East Anglia ONE North Offshore Wind Farm

Natural England's Red-Throated Diver Displacement Clarification Note

Planning Inspectorate Reference: EN010077

25th March 2021

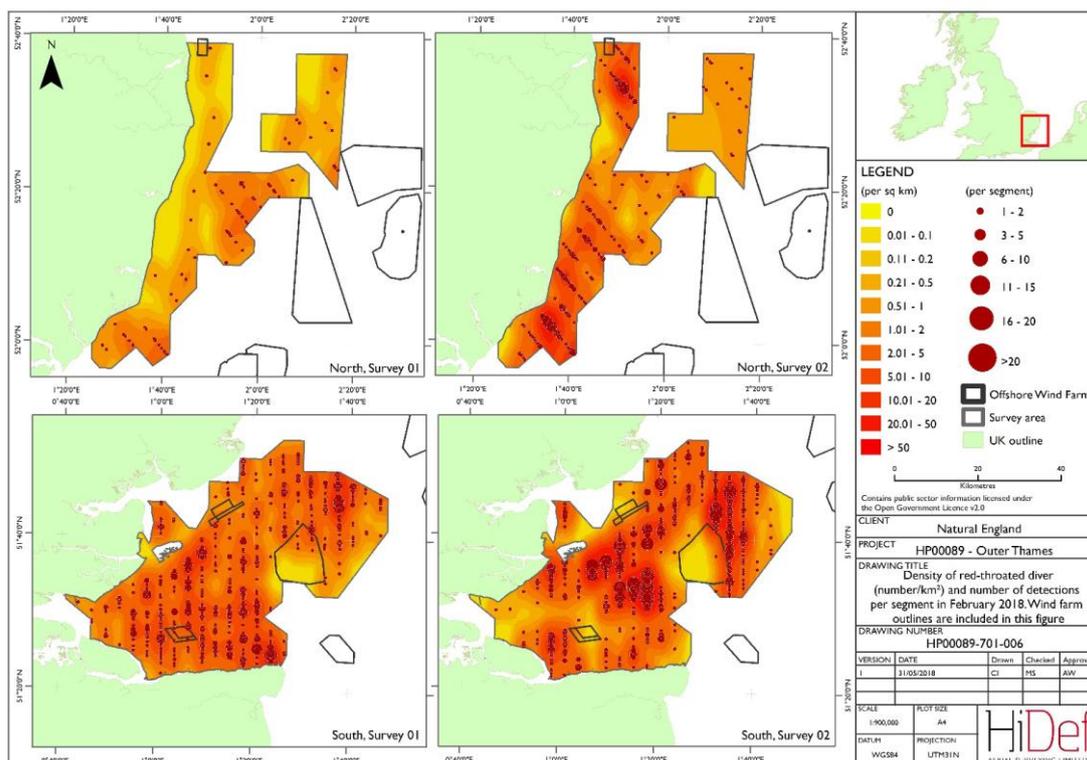
9. It is not possible to meaningfully compare the distribution and density reported in O'Brien et al. (2012), and that presented in the most recent surveys (Irwin et al. 2019), particularly without the outlines of the windfarms for context. However, when looking at Figure 8 from Irwin et al. 2019 (see figure below) which includes densities of red-throated diver (number/km²) together with the windfarm outlines, it is possible to see the effect of existing windfarms on diver distribution.

10. The lower densities of RTDs within windfarm footprints is clearly demonstrated in the bottom right image in Figure 8, and the largest density of divers is equidistant from the three windfarms – London Array, Kentish Flats and Gunfleet Sands.
